APPENDIX 1 – Observations by Mullin Design Associates on behalf of Mountaineering Ireland

Gruggandoo Windfarm Revised Submission 2020

Gruggandoo Viewpoint 1

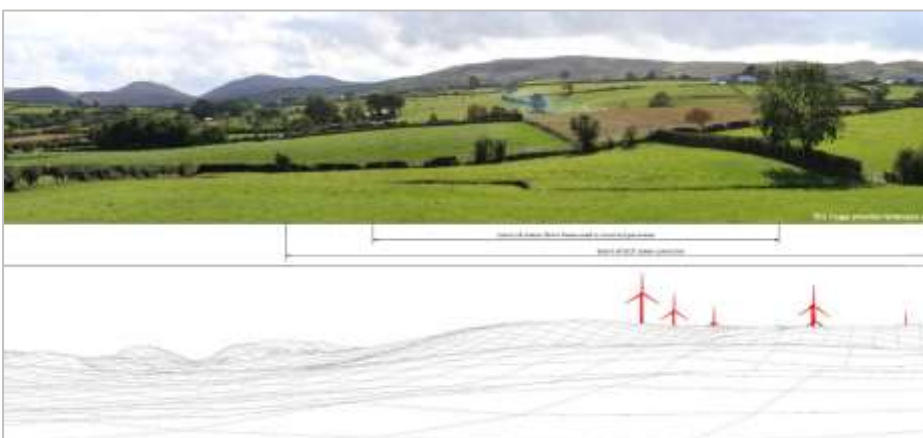
In addition to a 'flattening' effect which diminishes the potential scale of the Mourne, particularly when viewed from the west, Viewpoint 1 also illustrates an example of stacking which generally should be avoided.

Fig 1.0 – Applicant’s ZTVI with LCA boundaries added in

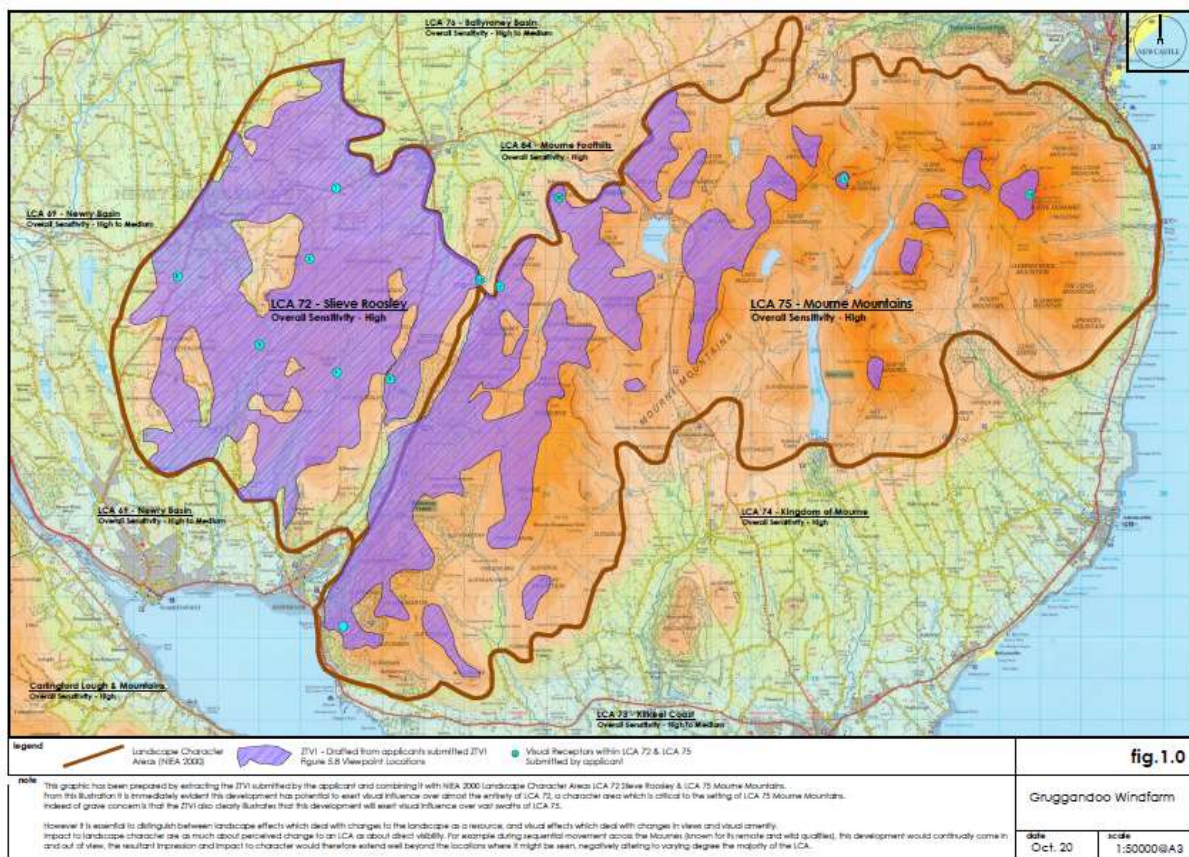
For example Viewpoint 17 - Rocky Mountain makes reference to The Ulster Way / The Mourne Way, however it does not go on to discuss the sequential experience along this route. Figure 1.0 below – (See Appendix 2 for detailed version) clearly shows the route of the Ulster Way as it passes 7 no. times in and out of the ZTVI along its length from East to West. This single example provides an indication of the importance of sequential experience in the context of this landscape resource with influence and therefore perception clearly extending far beyond those areas simply modelled by the ZTVI software.

From this illustration it is immediately evident this development has potential to exert direct visual influence over almost the entirety of the **High** sensitivity LCA 72, (a character area which is critical to

the setting of the Mournes) and across vast swathes (over 3111sq Hectares) of the indisputably **High** sensitivity LCA 75 Mourne Mountains. To consider the potential change to this iconic LCA 75 as **'small'**, with the profound implications which a development of this nature would result in is considered incomprehensible.
